02.00 ROOF PLANTS & EXTENSIONS - PROPOSED AMENDMENTS

Planning Application 2020/1350/P

**PROPOSED
AMENDMENTS VIEWS**

02.22 SECTION BB

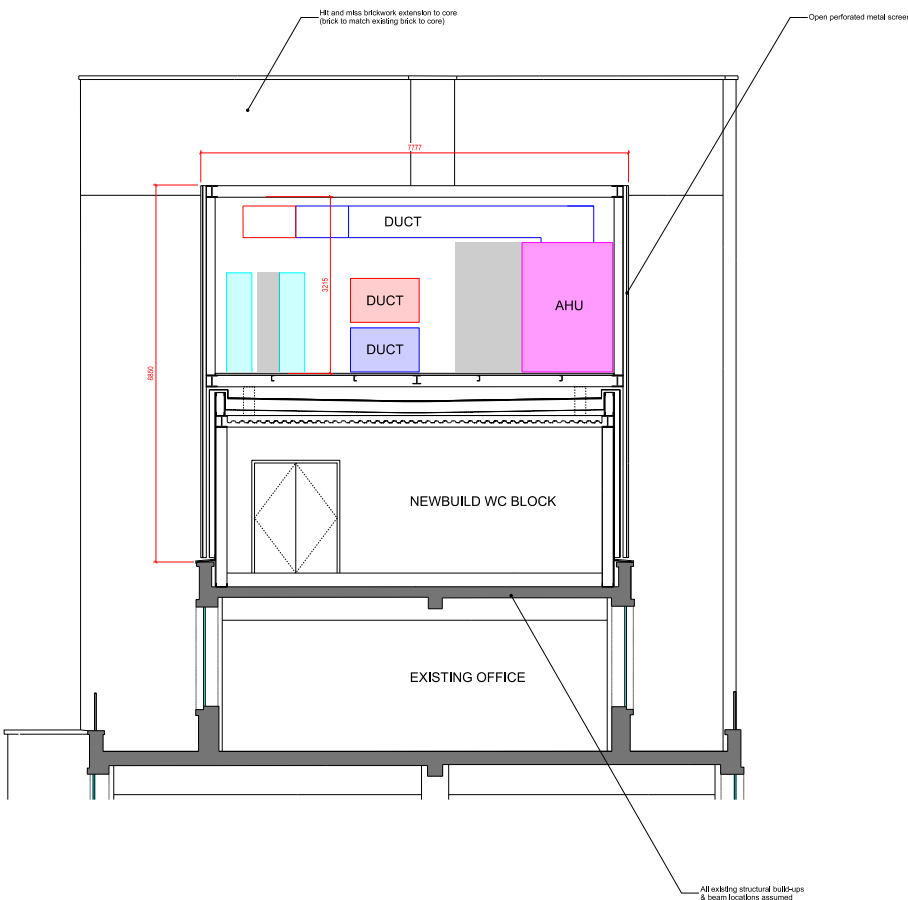
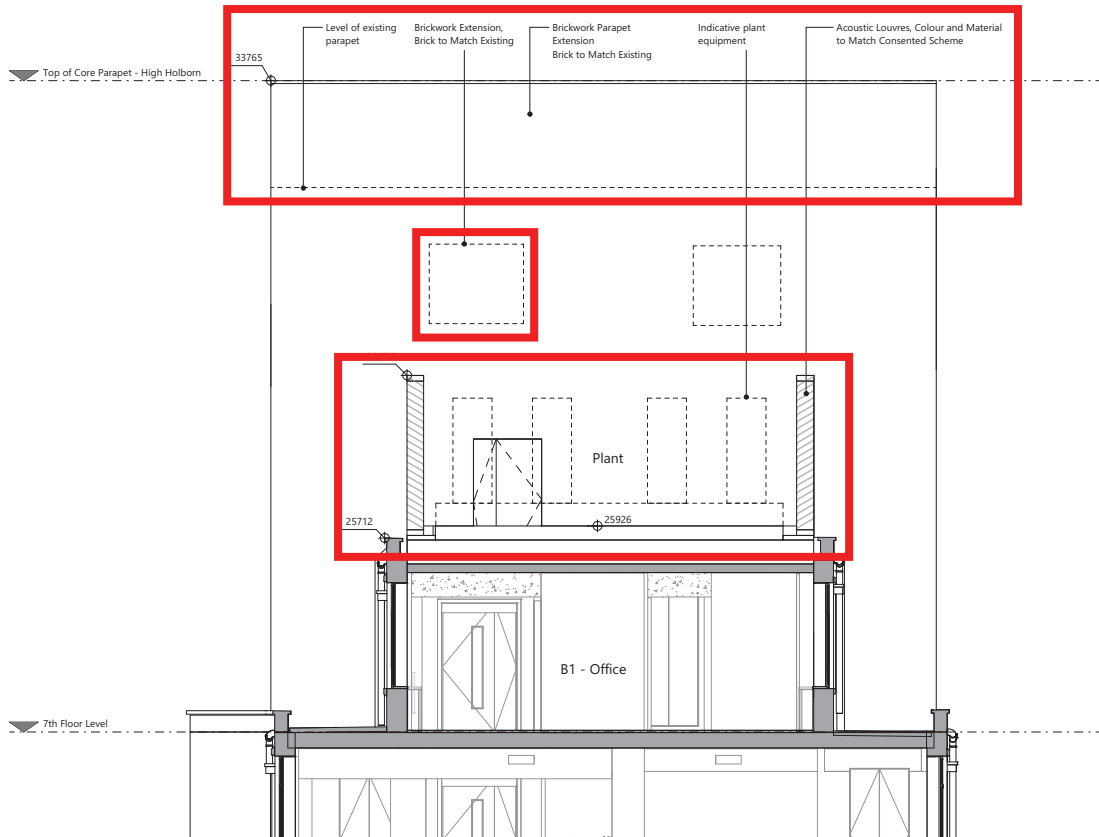
- LINK BLOCK
- Toilet block extension omitted.
 - Plant acoustic screening height reduced . Colour and material matching consented scheme.
- HIGH HOLBORN BLOCK
- Height reduction of High Holborn Core brick parapet extension.
 - Brickwork infill to existing window. Brick to match existing.

02.00 ROOF PLANTS & EXTENSIONS - PROPOSED AMENDMENTS
02.24 SECTION CC

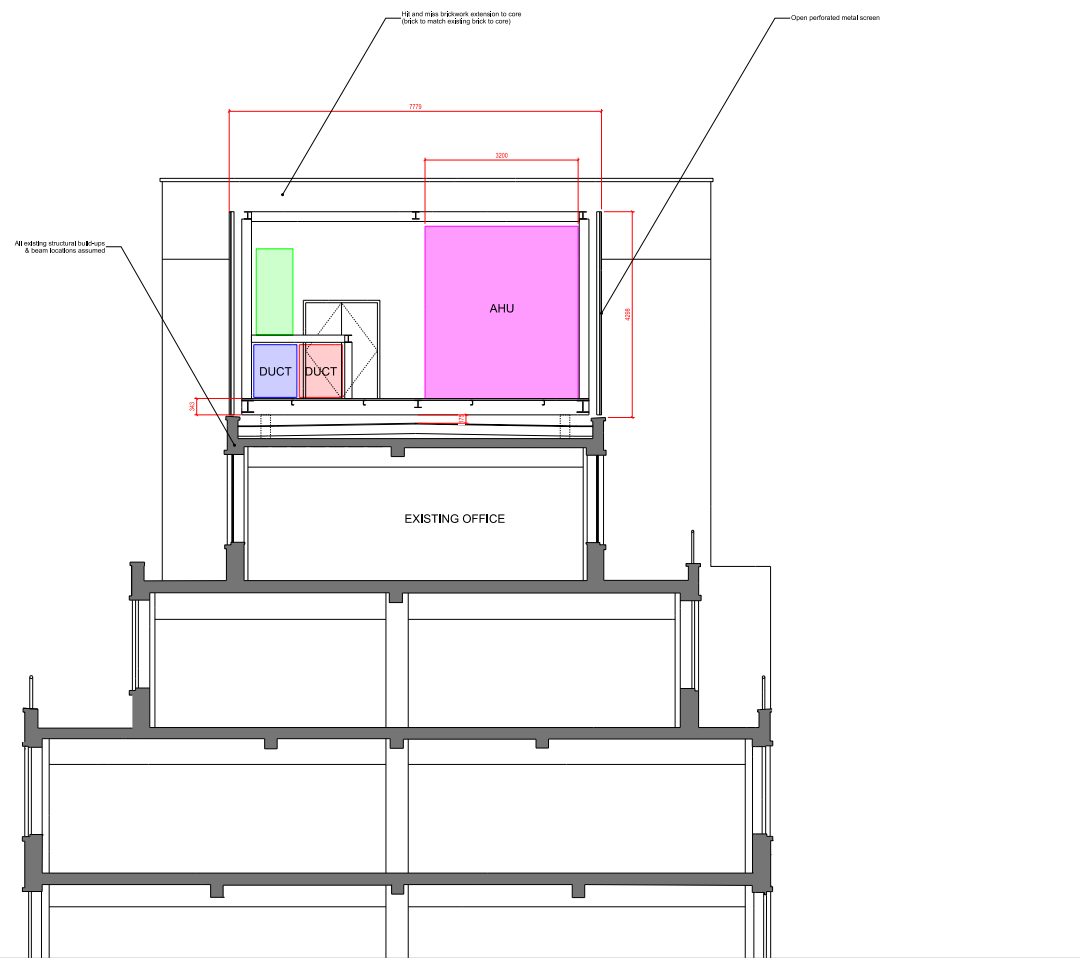
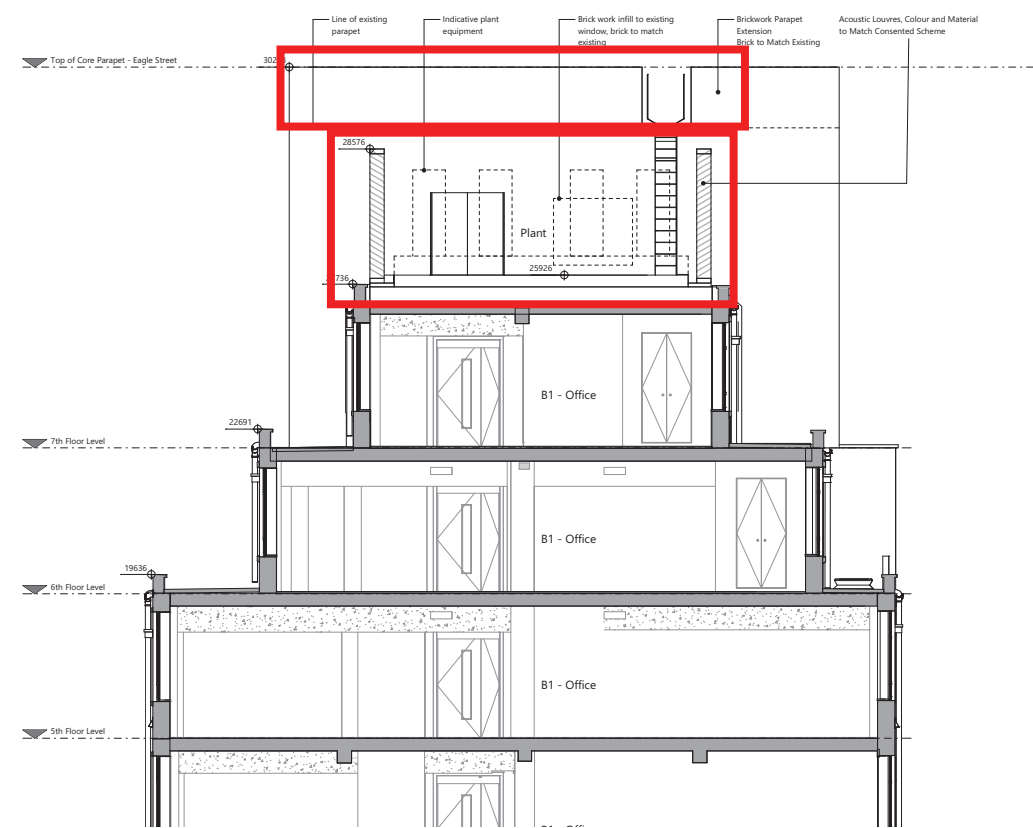
- LINK BLOCK
- Toilet block extension omitted.
 - Plant acoustic screening height reduced . Colour and material matching consented scheme.
- EAGLE STREET CORE
- Brickwork parapet extension. Brick to Match existing.
 - Works to core slab omitted.
 - Lift overrun as existing.
 - New cat ladder to allow core roof access from link block roof.
 - Brickwork infill to existing window. Brick to match existing.

02.00 ROOF PLANTS & EXTENSIONS - PROPOSED AMENDMENTS
02.26 SECTION DD

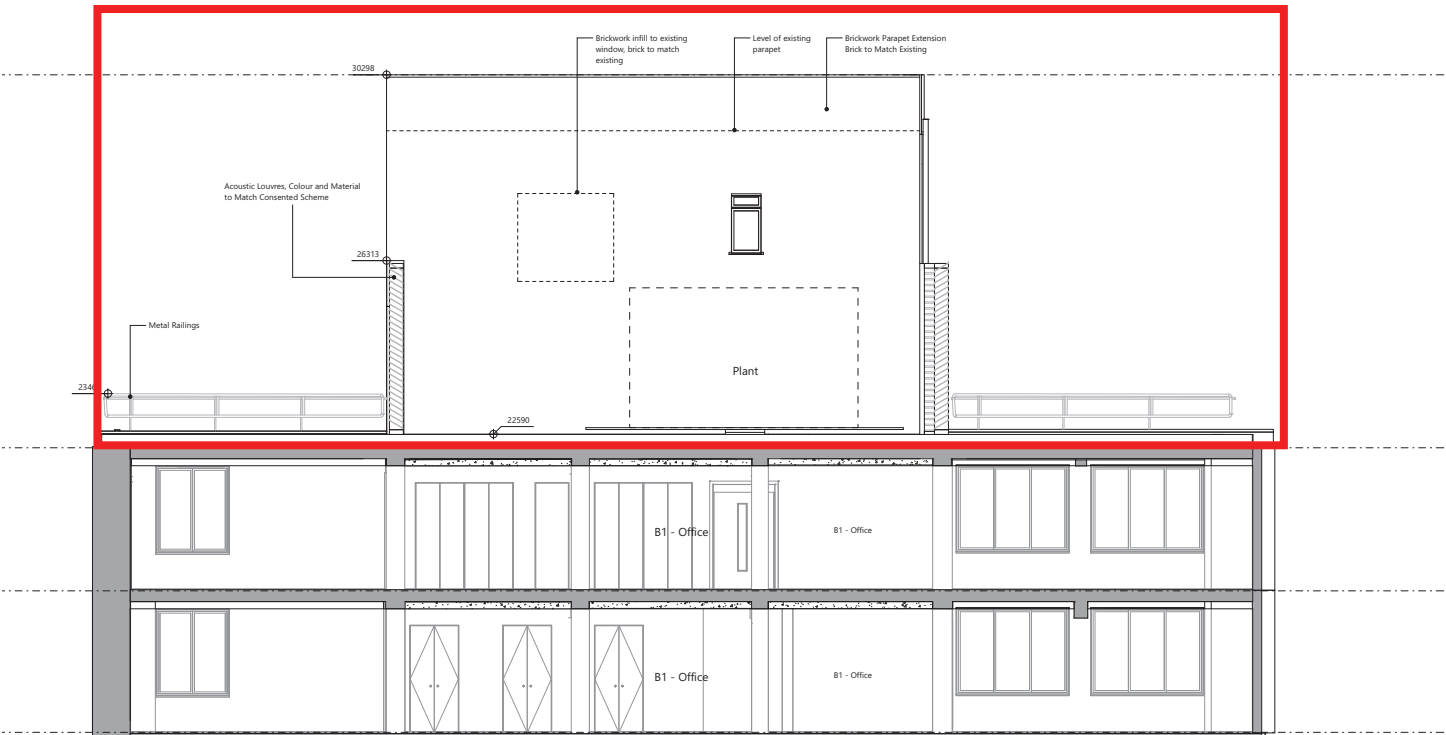
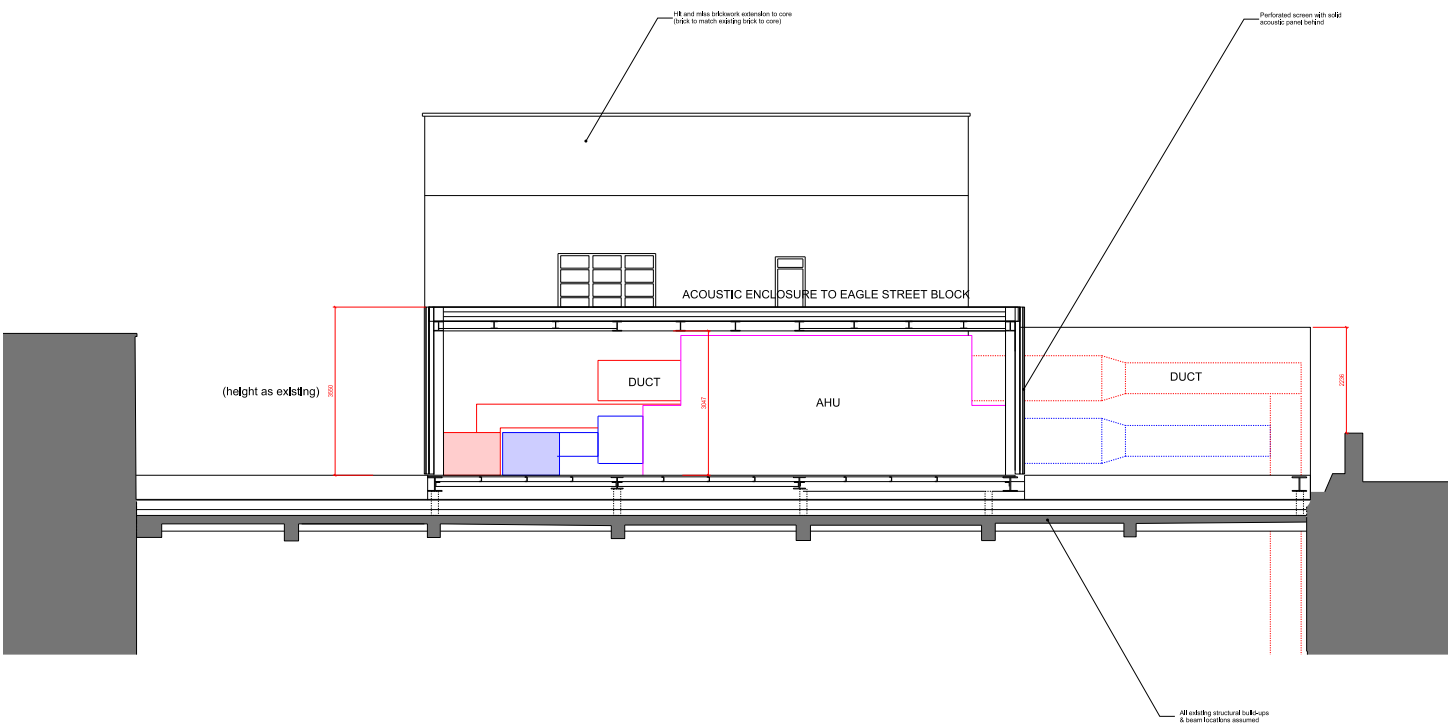
- EAGLE STREET BLOCK
- Plant acoustic screening extent reduction. Height and footprint as existing. Colour and materiality to match consented scheme.
 - New metal railings to Eagle street front and back parapets.
- EAGLE STREET CORE
- Brickwork parapet extension. Brick to Match existing.
 - Works to core slab omitted.
 - Brickwork infill to existing window. Brick to match existing.

02.00 ROOF PLANTS & EXTENSIONS - PROPOSED AMENDMENTS
02.28 SECTION EE 1

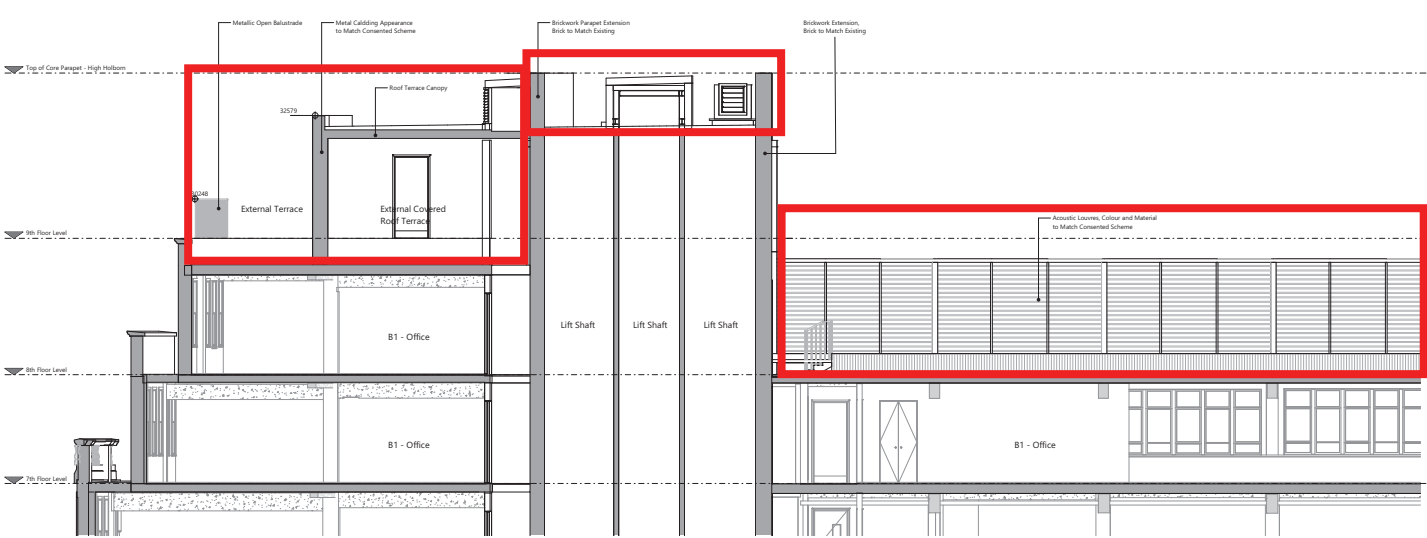
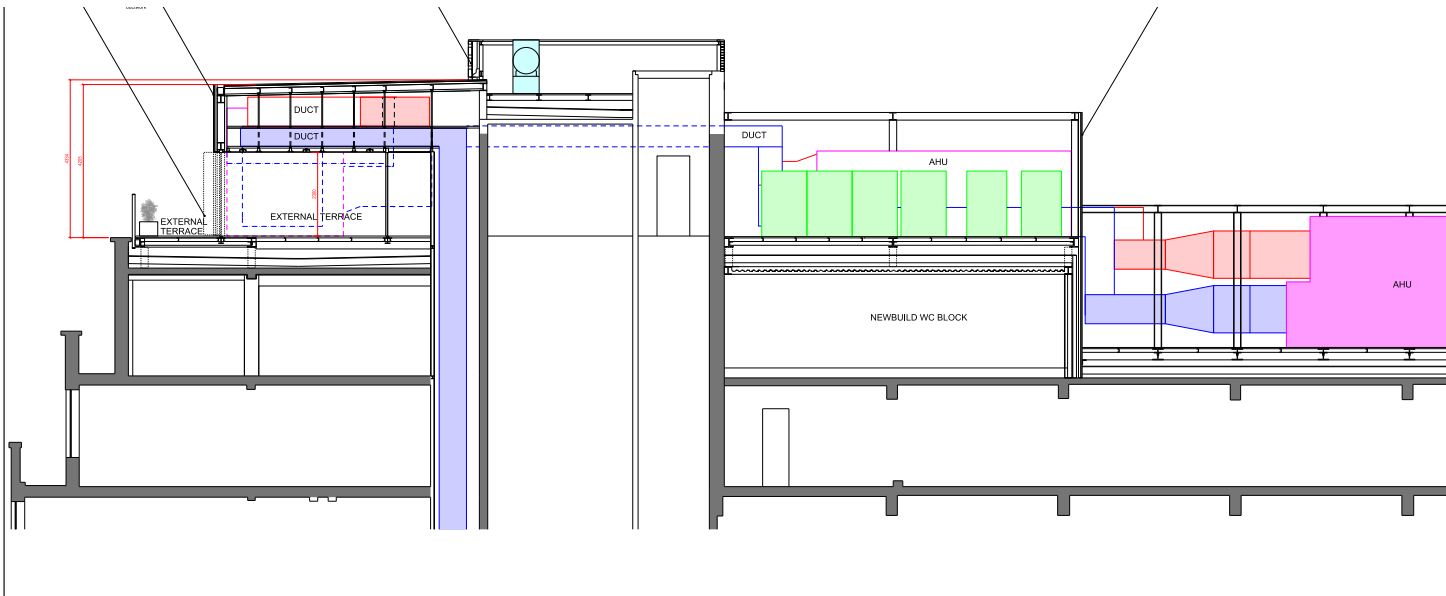
- Toilet block extension omitted.
- Plant acoustic screening height reduced . Colour and material matching consented scheme.

- Omission of plant equipment and enclosure, plant relocated to link block roof.
- New metallic railing to match consented scheme on all sides of the accessible roof
- Covered terrace height reduced and appearance to match consented scheme.
- Height reduction of High Holborn Core brick parapet extension. Brick to match existing.

02.30 SECTION EE 2

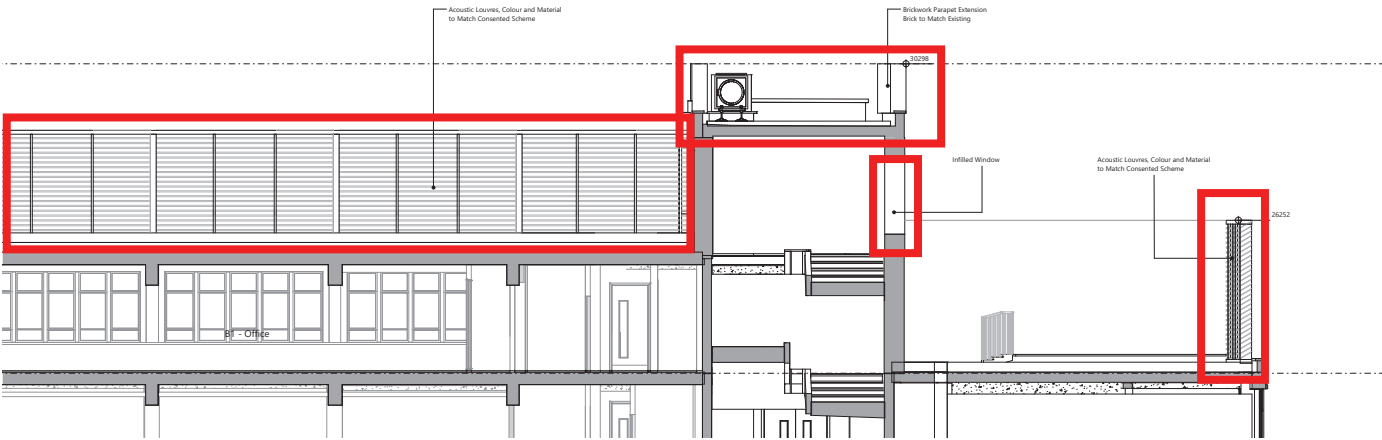
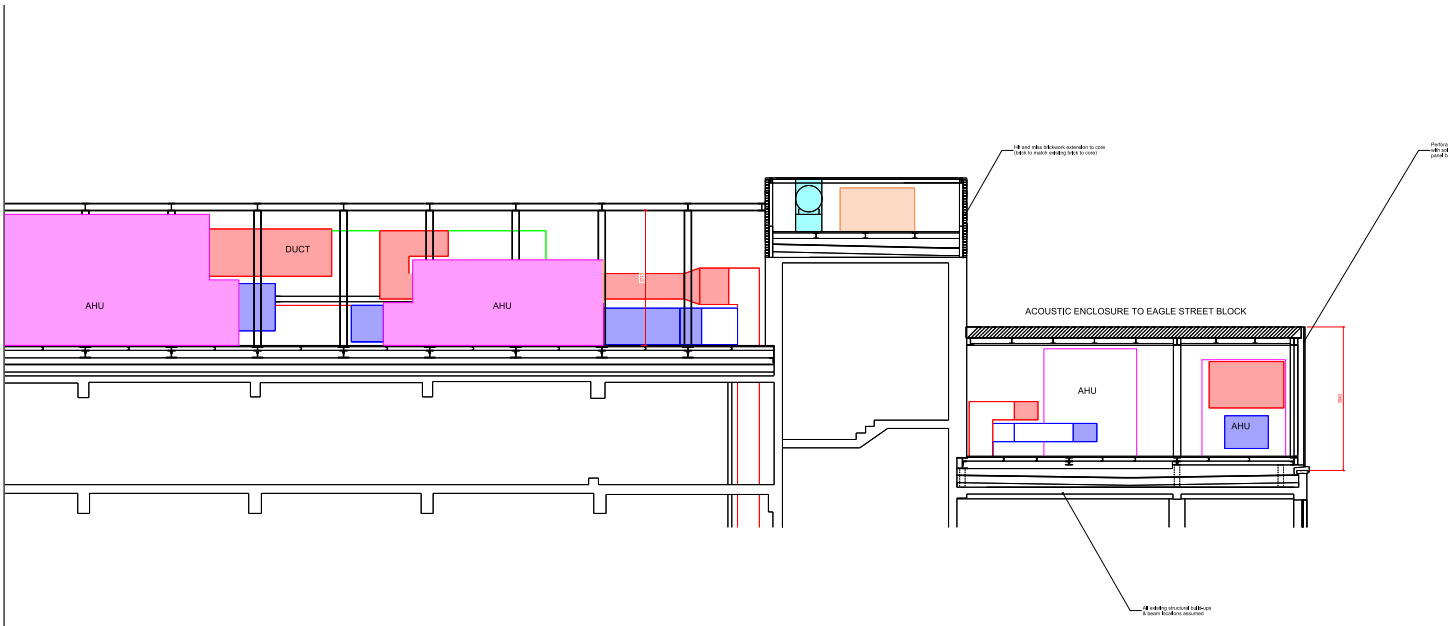
- Plant acoustic screening height reduced . Colour and material matching consented scheme.

- Brickwork parapet extension. Brick to Match existing.
- Works to core slab omitted.
- Lift overrun as existing.
- Brickwork infill to existing window. Brick to match existing.

- Plant acoustic screening extent reduction. Height and footprint as existing. Colour and materiality to match consented scheme.
